DEPARTMENT OF TRANSPORTATION**Federal Aviation Administration****14 CFR Part 36**

[Docket No. FAA-1998-4731; Amendment No. 36-22]

Noise Certification Standards for Propeller-Driven Small Airplanes

ACTION: Final rule.

MEASUREMENT WINDOW FOR NO ABSORPTION CORRECTION
Figure G1

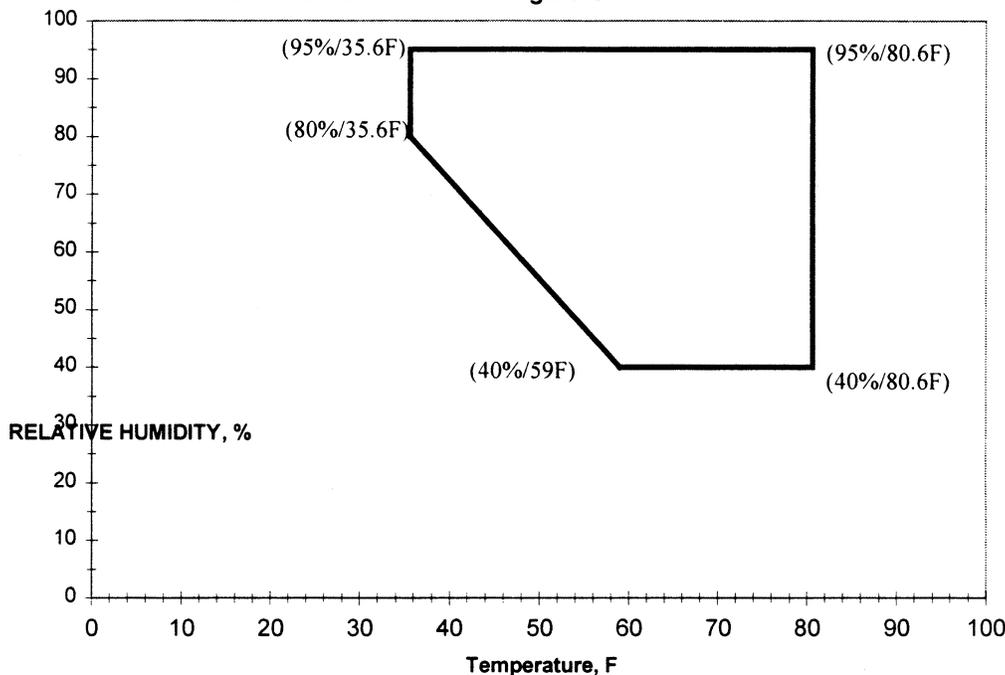
Current § G36.201(b) requires atmospheric absorption correction for noise data obtained when the test conditions are outside those specified in appendix G, figure G1. Noise data collected outside the prescribed range of figure G1 are required to be corrected to 77 degrees Fahrenheit and 70 percent relative humidity by an FAA approved method. The FAA proposed changing the 77 degrees Fahrenheit reference temperature to 59 degrees Fahrenheit, to be consistent with the ambient temperature requirement in current § G36.111(b)(2), that is used for performance calculations.

Aeromod Services, Inc. objects to changing the 77 degree Fahrenheit reference temperature to 59 degree Fahrenheit in paragraph (b) because it "harmonizes in the wrong direction." The commenter says that the section should be "placed on the list for JAR 36 harmonization with FAR 36."

If we examine the existing FAA and ICAO noise rules, we find that the only rule which does not have a primary or absolute acoustical reference day defined by 77°F/70%RH is Annex 16, Chapter 10. All of the other noise rules, to include FAR 36 Appendix A, Current Appendix G, Appendix H, ICAO Annex 16 Chapter 3, Chapter 4, and Chapter 8, use 77°F/70%RH as the primary or absolute acoustical reference day.

Aeromod comments that the only section of part 36 which does not have both the performance and acoustic reference day conditions as 77 degree Fahrenheit and 70 percent relative humidity is Appendix G. The reason for this apparent inconsistency is based on the different noise characteristics of other airplane classes, namely large transports and helicopters. Propeller-driven small airplane noise levels are dominated by the low frequency tone noise under 500 Hz. Other classes of airplanes have noise characteristics that can be concentrated at higher frequencies. This difference in noise characteristics is reflected in the regulations by the different atmospheric absorption correction requirements for each class of airplanes.

The regulation requires that an atmospheric absorption correction at 500 Hz $\frac{1}{3}$ -octave-band frequency must be applied to the measured noise levels of propeller-driven small airplanes. For large transports and helicopters, the measured levels have to be corrected to reference conditions of 77 degree Fahrenheit by applying atmospheric absorption correction for each $\frac{1}{3}$ -octave-band frequency. The atmospheric absorption is minimal at 500 Hz and increases with the increase in frequency. The correction is always small for propeller-driven small airplanes and can be very large for other

classes of airplanes. The choice of the 77 degree Fahrenheit reference temperature assures that the measured levels are corrected upwards for most large transport and helicopter tests since a typical test temperature is lower than 77 degree Fahrenheit. If a low reference temperature was chosen, the cumulative effect of the corrections could become positive or negative depending on the frequency content of the noise from the large transport and helicopters being tested. This effort would benefit some aircraft and unfairly penalize other aircraft depending on the test day temperature and frequency content. The high reference temperature of 77 degree Fahrenheit removes this uncertainty for large transport and helicopter noise certification testing.

However, the small atmospheric absorption correction values at low frequencies for propeller-driven airplanes do not warrant the use of a reference atmospheric temperature of 77 degree Fahrenheit which is different than standard reference conditions used in most aircraft testing. In the field of aeronautics, the International Standard Atmosphere (ISA) is usually used as the standard ambient conditions, and uses a temperature as 59 degrees Fahrenheit. All the performance information in the flight manuals (carried aboard each airplane) are given for ISA conditions. The proposed changes to Appendix G simplifies the data reduction by uniting the performance and acoustic reference conditions for propeller-driven small airplanes at 59 degrees Fahrenheit and 70 percent relative humidity. This section was adopted as proposed.

(b) Atmospheric absorption correction is required for noise data obtained when the test conditions are outside those specified in Figure G1. Noise data outside the applicable range must be corrected to 59 F and 70 percent relative humidity by an FAA approved method.

**NOISE LEVELS vs AIRPLANE WEIGHT
FIGURE G2**

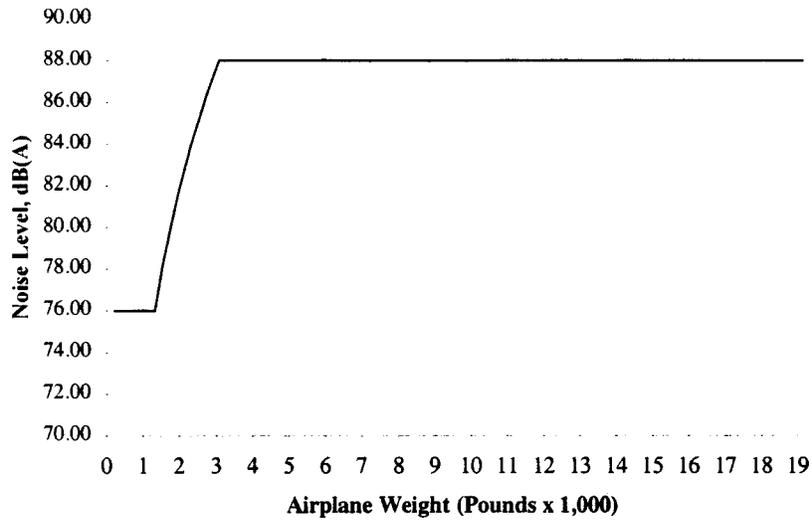
Current § G36.301(b) states that for aircraft weights up to 1,320 pounds (600 kg) the noise level must not exceed 73 dB(A); for weights greater than 1,320 pounds, the noise limit increases at the rate of 1 dB /165 pounds up to 85 dB(A) at 3,300 pounds, after which the noise level remains constant at 85 dB(A) up to and including aircraft weight of 19,000 pounds.

As previously discussed, considerations of microphone location, configuration, and resulting noise limits are interrelated. Since the proposed changes to the noise measurement procedures of § G36.107(a) would result in increases in the measured noise levels of about 3 dB(A), the FAA proposed to increase the limits in § 36.301(b) from 73 dB(A) to 76 dB(A) and from 85 dB(A) to 88 dB(A) to account for these different measurement procedures, but without changing the stringency of the current rule.

In addition to the dB(A) increases discussed, the FAA proposed a change to the interpolation requirement of § G36.301(b). For airplane weights greater than 1,320 pounds, the allowable

dB(A) would increase "with the logarithm of airplane weight at the rate of 9.83 dB(A) per doubling of weight until the limit of 88 dB(A) is reached * * *," rather than at the rate of 1 dB/165 pounds up to 85 dB(A) at 3,300 pounds, as under the current rule. The new logarithmic interpolation between the low and high takeoff weights was adopted from the Annex 16, Volume I Chapter 10. The working group analyzed the available data obtained by use of a ground microphone, and decided to adopt the logarithmic interpolation that is between low and high takeoff weights.

The only comment regarding this section did not object to the proposed change; § G36.301(b) is adopted as proposed.

(b) The noise level must not exceed 76 dB (A) up to and including aircraft weights of 1,320 pounds (600 kg). For aircraft weights greater than 1,320 pounds, the limit increases from that point with the logarithm of airplane weight at the rate of 9.83 dB (A) per doubling of weight, until the limit of 88 dB (A) is reached, after which the limit is constant up to and including 19,000 pounds (8,618 kg). Figure G2 shows noise level limits vs airplane weight.
